## **Access Compliance Report Public Rights-of-Way** (Island Curb Cuts)

Intersection ID: 28003 Main Street: COMMUNITY HOUSE RD Cross Street: WILLOW\_ROCK\_DR Location: W ADA ID: 9826BE290C46 Curb Cut Type: MedianRefuge2 Initial Pass/Fail: Fail **Overall Compliance: No** Severity Score: 1.25

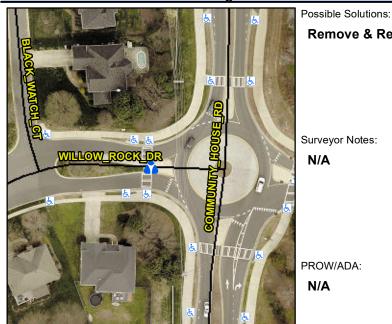
i icia ilicasui (		JIIIP	onent compnance
Com	pliance Description	Data	Com	pliance Description
Yes	Refuge 1 Length (In)	62.5	N/A	Gutter 1 Ponding?
Yes	Refuge 1 Width (In)	72.0	N/A	Gutter 1 Lip Ht (In)
Yes	Refuge 1 Slope (%)	3.1	N/A	Gutter 1 Slope (%)
Yes	Refuge 1 X Slope (%)	3.3	N/A	Gutter 1 X Slope (%)
N/A	Painted X Walk1?	Yes	N/A	DWS 1 Provided?
N/A	X Walk 1 Direction	To S	N/A	DWS 1 Contrast?
N/A	X Walk 1 Width (In)	128.0	N/A	DWS 1 Length (In)
N/A	Road 1 Slope (%)	2.2	N/A	DWS 1 Full Width?
N/A	Road 1 X Slope (%)	2.0	N/A	DWS 1 Offset (In)
Yes	Refuge 2 Length (In)	62.5	N/A	Gutter 2 Ponding?
Yes	Refuge 2 Width (In)	72.0	N/A	Gutter 2 Lip Ht (In)
Yes	Refuge 2 Slope (%)	0.5	N/A	Gutter 2 Slope (%)
Yes	Refuge 2 X Slope (%)	2.7	N/A	Gutter 2 X Slope (%)
N/A	Painted X Walk2?	Yes	N/A	DWS 2 Provided?
N/A	X Walk 2 Direction	To N	N/A	DWS 2 Contrast?
N/A	X Walk 2 Width (In)	129.0	N/A	DWS 2 Length (In)
N/A	Road 2 Slope (%)	2.8	N/A	DWS 2 Full Width?

Remove & Replace Entire Refuge.
